GROUP	MODEL
BOD	2022MY Carnival (KA4)
NUMBER	DATE
303	December 2021

## TECHNICAL SERVICE BULLETIN

### SERVICE ACTION: NOISE WHEN OPENING AND CLOSING FUEL FILLER DOOR (SA486)

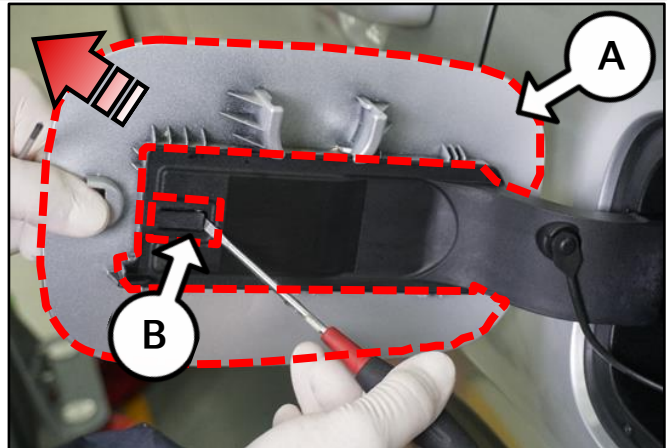
1. Open and close the fuel filler door (A) two (2) times.
  - If a “squeak” or rubbing noise is heard when opening or closing the door, proceed to the Repair Procedure to attach non-woven pads to the door.

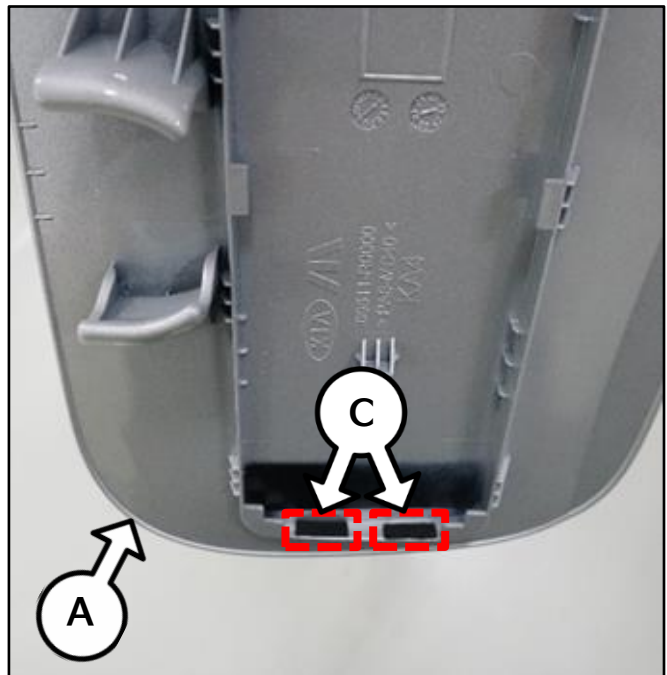
1. Inside the fuel door (A), release the fuel door cover locking tab (B) using a flat-head screwdriver.

Detach the fuel door cover (A) by pulling it outward in the direction of the arrow.

2. Attach two (2) pads (C), PN 81595 R0001QQK, one at each outer end of the fuel filler door panel (A) as shown.
3. Reassemble the fuel filler door in the reverse order of disassembly.

**Note:** When reinstalling the fuel filler door panel, push the panel until a “tick” sound is heard to ensure it is securely attached.

- 4a. Verify the squeak/rubbing noise is no longer present by opening and closing the fuel filler door two (2) times.
- 4b. If the noise is still heard, repeat the Repair Procedure to attach two (2) more pads on top of the previously attached ones (one on each side).
